**RE: Casey's on Wedington City Council Appeal from Planning Commission**

A RESOLUTION TO GRANT THE APPEAL AND APPROVE A LARGE SCALE DEVELOPMENT (LSD-4295) FOR CASEY'S GENERAL STORES, INC.

**LSD 12-4295: Large Scale Development (2530 W. WEDINGTON RD./CASEY GENERAL STORE, 402):** Submitted by BATES AND ASSOCIATES for property located at 2530 WEST WEDINGTON ROAD. The property is zoned C-2, THOROUGHFARE COMMERCIAL and contains approximately 1.54 acres. The request is for 4,223 square foot convenience store with associated parking. Planner: Jesse Fulcher

Right-in design requested  
by applicant -  
Denied by Planning  
Commission.

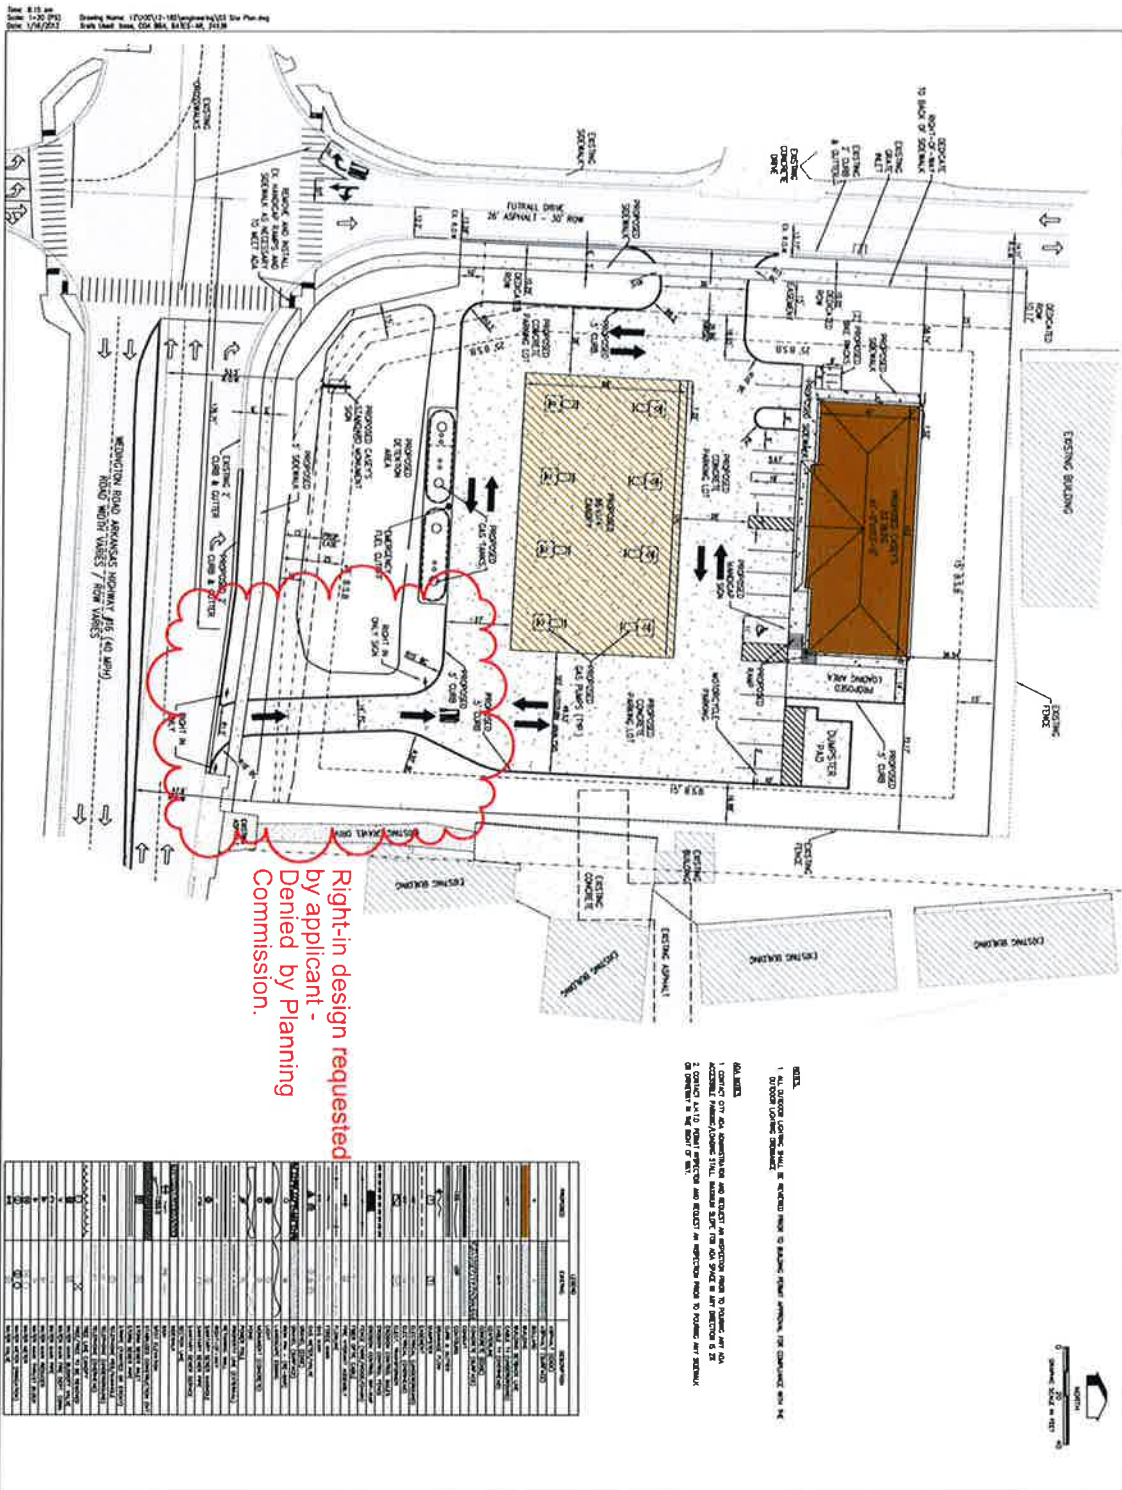
*March 11, 2013 Planning Commission:* The Planning Commission made a motion to approve a modified right-in only design with final design approval required from the Arkansas Highway and Transportation Department and City Engineer. The motion failed with a vote of 3-5-0. The Planning Commission then made a motion to approve the large scale development as requested by the applicant, finding in favor of the right-in design and tree preservation plan. The motion failed with a vote of 3-5-0.

| Existing Canopy: 19.6% | *Preserved Canopy: 4.3% | Required Canopy: 15% |

Right-in design  
submitted for  
City Council review.

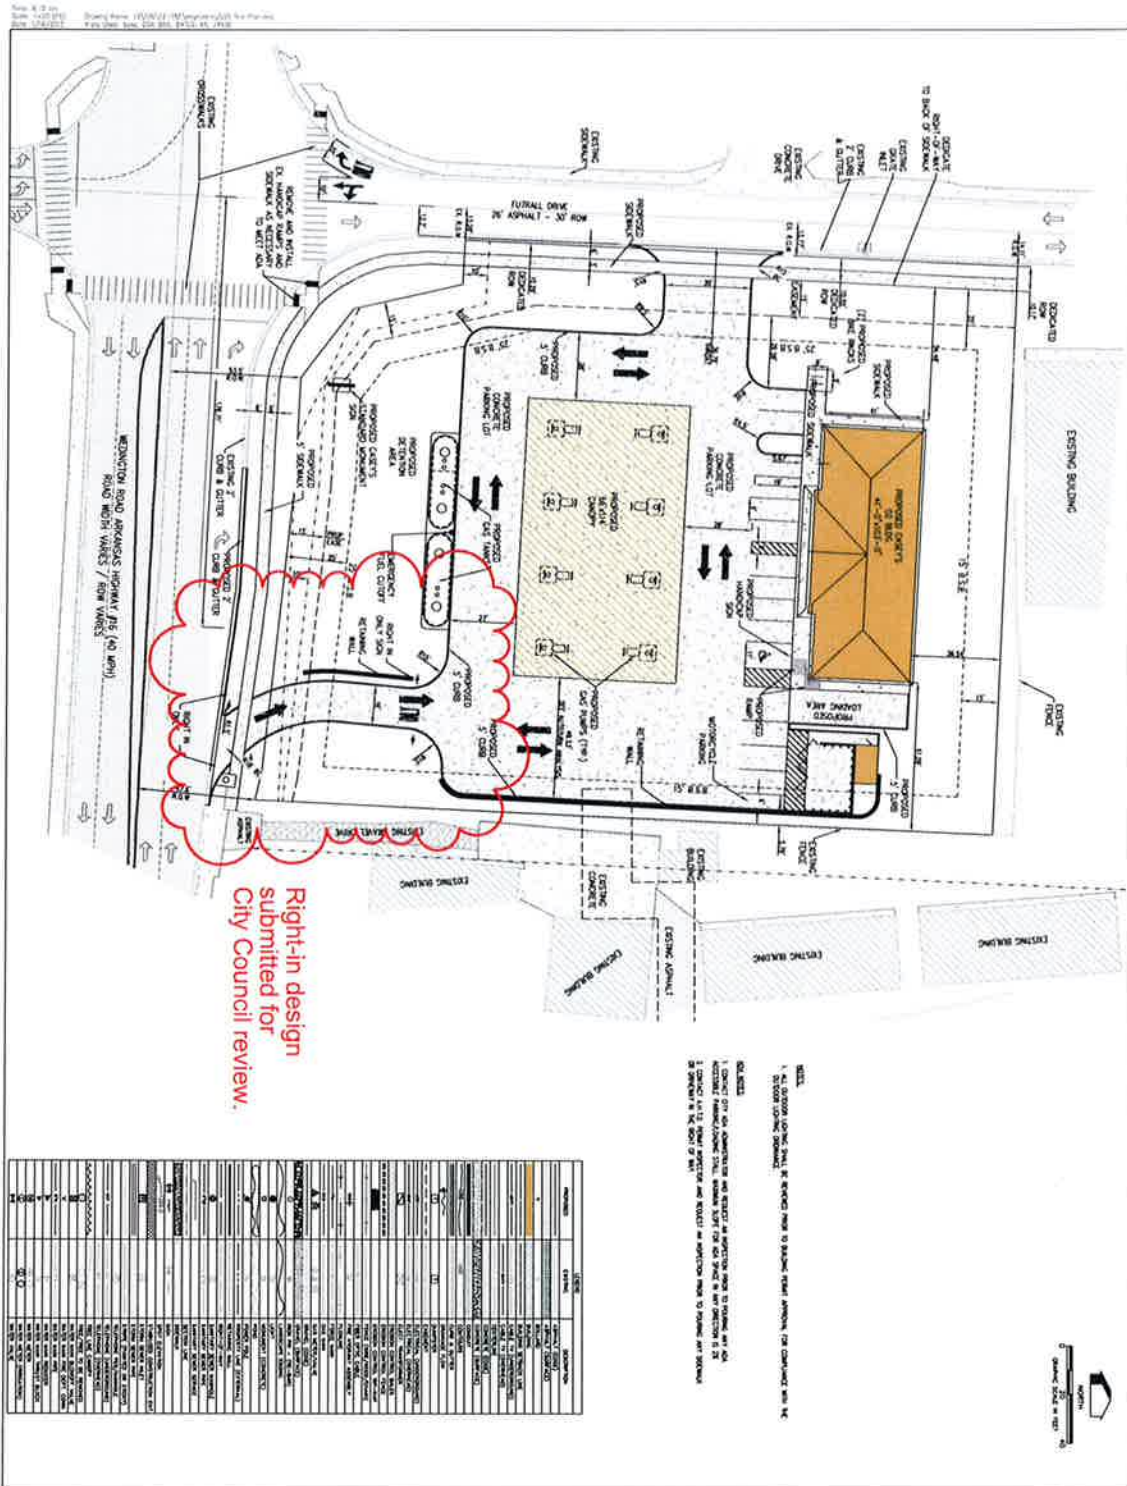
In addition, a right turn only was requested off of Wedington Drive. The planning department did not feel it was restrictive enough. In our most recent submittal to the City Council we've created a smoother turn off of Wedington Drive and made the entrance more restrictive for eastbound travelers.

April 2, 2013  
Tree Preservation Plan  
submitted for City  
Council review.

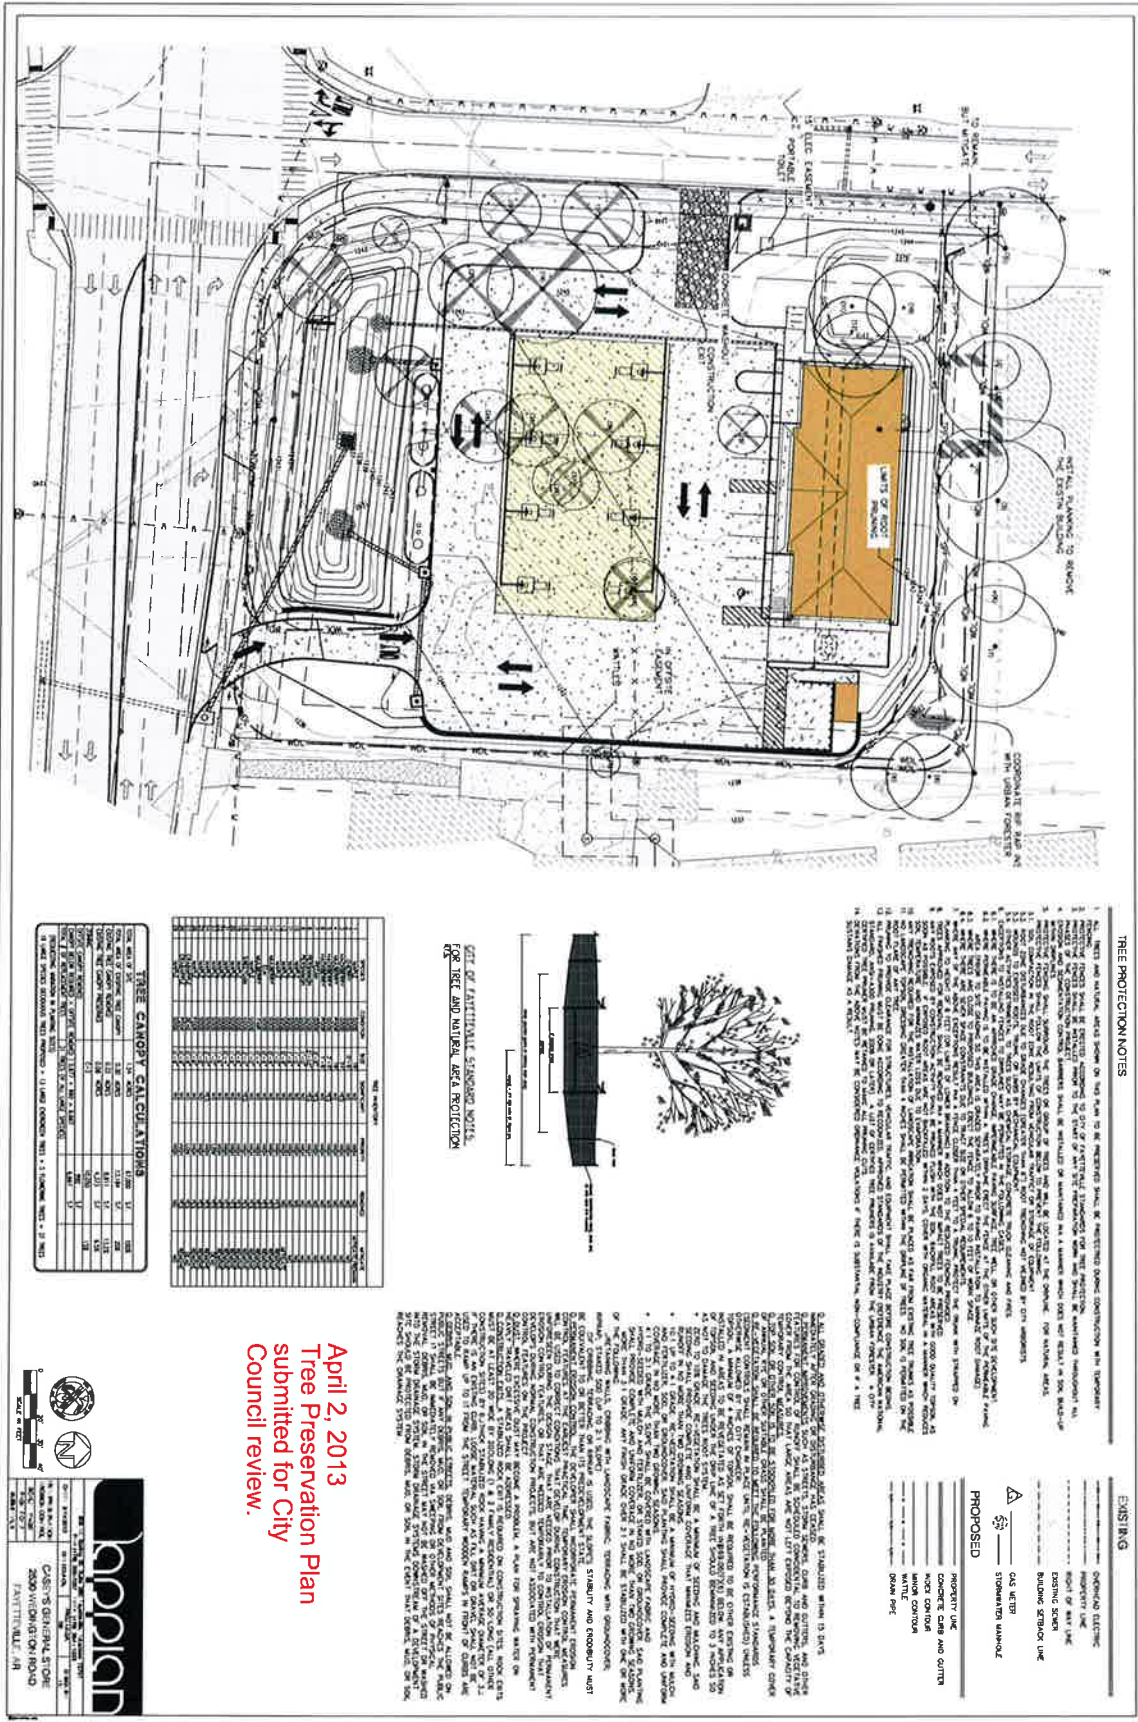
5. Planning Commission determination of the Tree Preservation Plan. *The Urban Forester is recommending denial of the project, finding that the plan does not meet the requirements of the Tree Preservation Ordinance and that no justification has been provided for the removal of trees #10-13.*

1. This application is recommended for DENIAL.
2. No justification in Analysis Report or Plan has been provided to remove Trees #10-13. The site design could be modified to shift the building and pump canopy to provide the following Tree Preservation Numbers.  
Removed: 7333 – 10.9%  
Preserved: 5851 – 8.7%  
Mitigation: 4199 + 990 offsite = 5189 = 24 trees

Our request to the Planning Commission on March 10<sup>th</sup> was denied due to tree preservation requirements. We have amended the tree preservation plan and saved more of the trees as requested by the Urban Forester.

FIGURE  
9

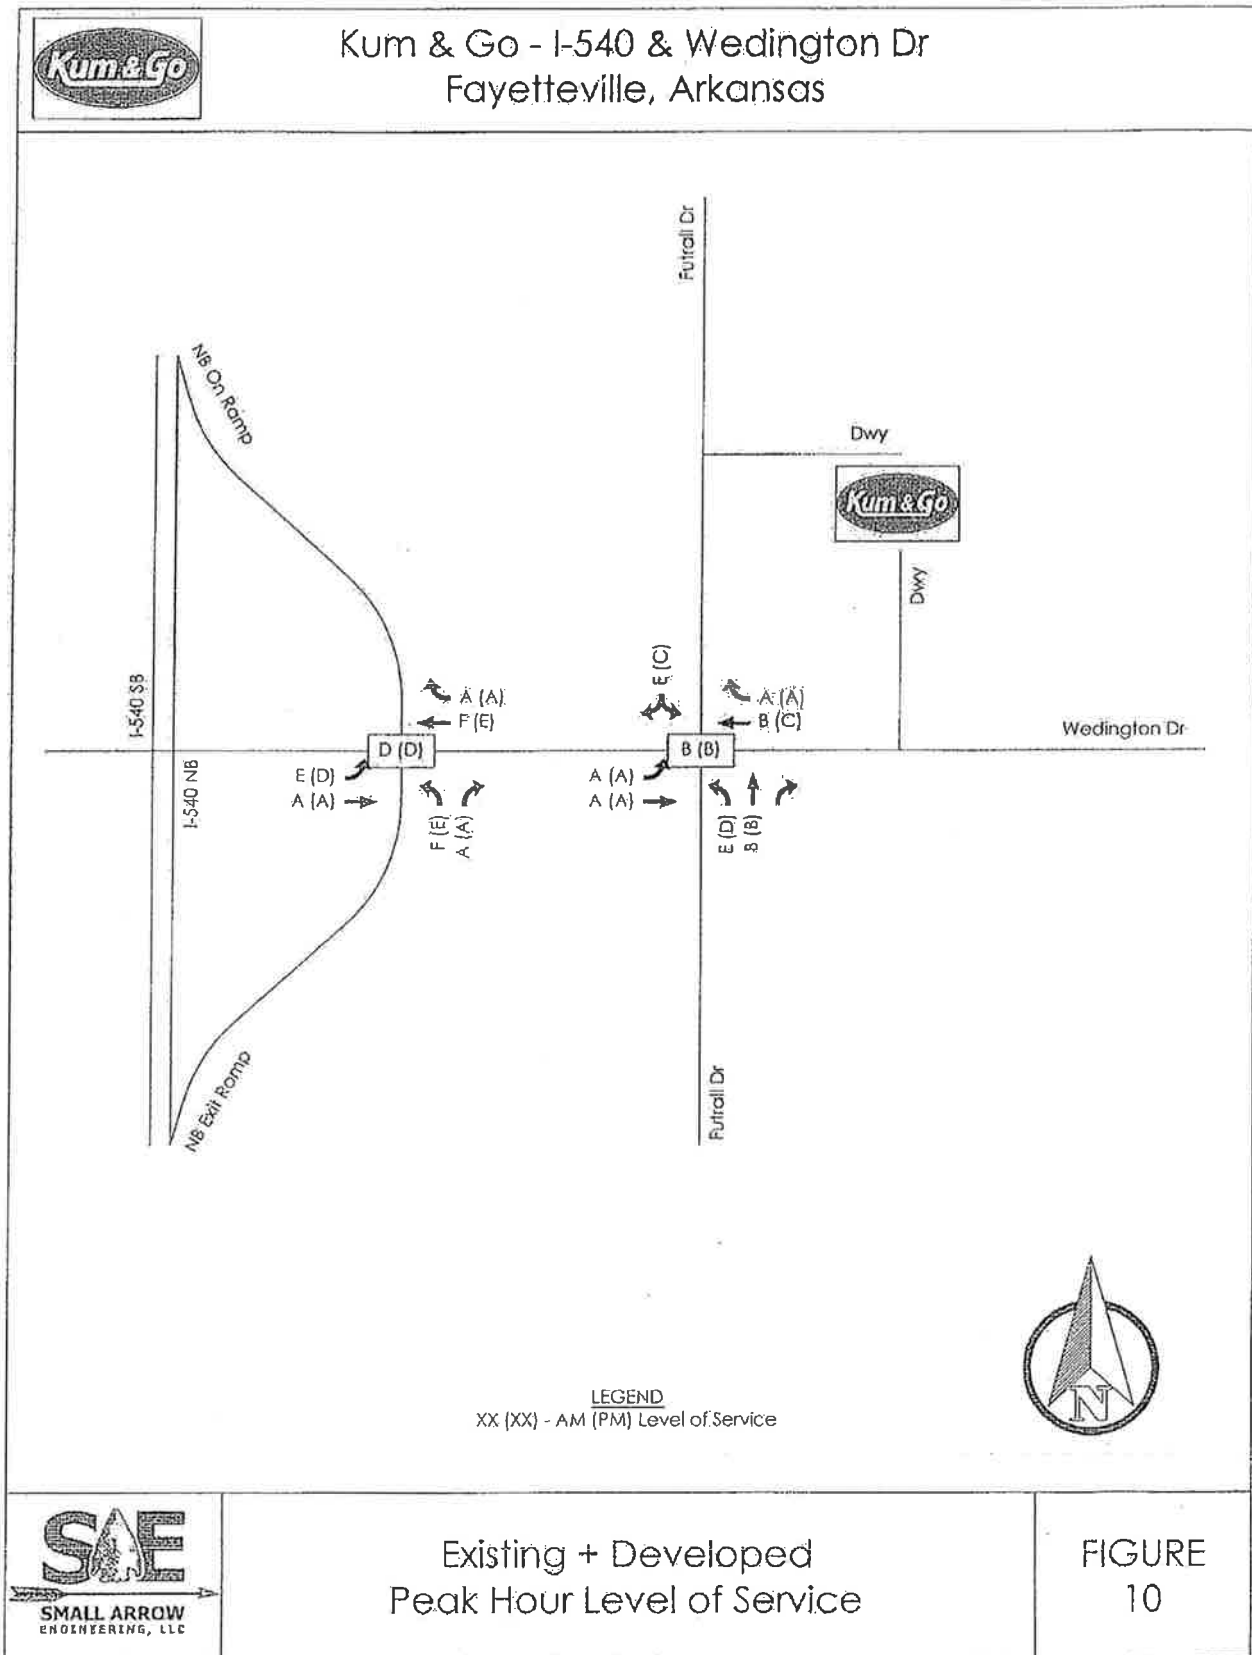
"Due to the high volume of eastbound thru traffic in the A.M. and the high volume of westbound thru traffic in the P.M., we recommend construction of a raised median island (Figure 9) on the east side of the Futrall Drive intersection creating a Right in/Right out only driveway for the development. Although this improvement will prevent the eastbound left turn into the development, it will also prevent a left turning vehicle from stopping in traffic and creating a queue through the intersections. One might suggest adding a Two Way Left Turn Lane (TWLTL), but due to the proximity of the entrance to the intersection, the westbound queuing at the intersection would prohibit any left in or left out movements during the peak hours."
